FORM APPROVED  
OMB NO. 1004-0135  
Expires: July 31, 2010**SUNDRY NOTICES AND REPORTS ON WELLS**  
*Do not use this form for proposals to drill or to re-enter an abandoned well. Use form 3160-3 (APD) for such proposals.*

5. Lease Serial No. NMLC030176A
6. If Indian, Allottee or Tribe Name
7. If Unit or CA/Agreement, Name and/or No. 8920003820
8. Well Name and No. R.F.U. 9-2
9. API Well No. 30-025-11968-00-S1
10. Field and Pool, or Exploratory RHODES
11. County or Parish, and State LEA COUNTY, NM

\*\* BLM REVISED \*\* BLM REVISED \*\* BLM REVISED \*\* BLM REVISED \*\* BLM REVISED \*\*

Cimarex Energy Co. of Colorado  
Rhodes Fed Unit #92  
900' FSL & 1650' FWL  
Sec 9- T26S - R37E, Lea Co NM  
API #30-025-11968

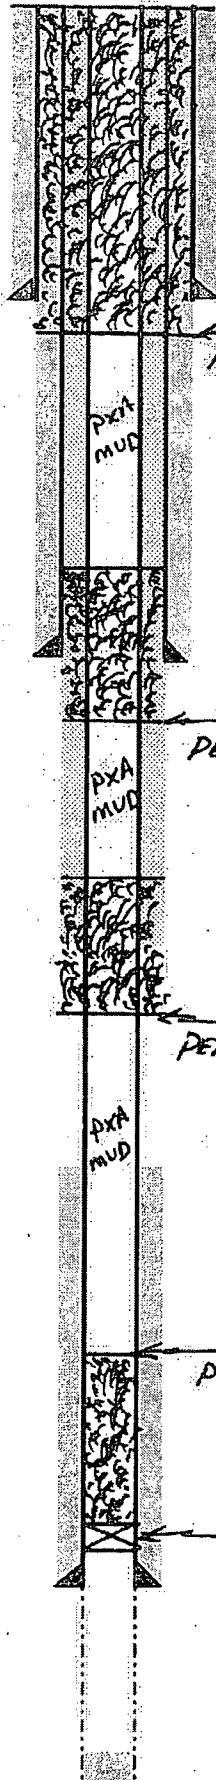
- 2480'
- 1) SET 7" CIBP @ 2,750'; PUMP 60 SXS.CMT. @ 2,750'-2,540'(B/SALT); WOC X TAG.
  - 2) ATTEMPT TO CIRC. WELL W/ PXA MUD.
  - 3) PERF. X ATTEMPT TO SQZ. 55 SXS.CMT. @ 1,855'-1,745'(CSG.LEAKS); WOC X TAG.
  - 4) PERF. X ATTEMPT TO SQZ. 75 SXS.CMT. @ 4,100'-960'(9-5/8"CSG.SHOE,T/SALT, T/ANHY.); WOC X TAG 1420 - 992 CMT. PLUG.
  - 5) PERF. X CIRC. TO SURF., FILLING ALL ANNULI, 100 SXS.CMT. @ 176'-3'.
  - 6) DIG OUT X CUT OFF WELLHEAD 3' B.G.L.; WELD ON STEEL PLATE TO CSGS. X INSTALL DRY HOLE MARKER.

*At cut-off verify amt to surf. all annulus*

1370  
T/SALT/ANHY-400  
B/SALT ~ 2590'  
2530
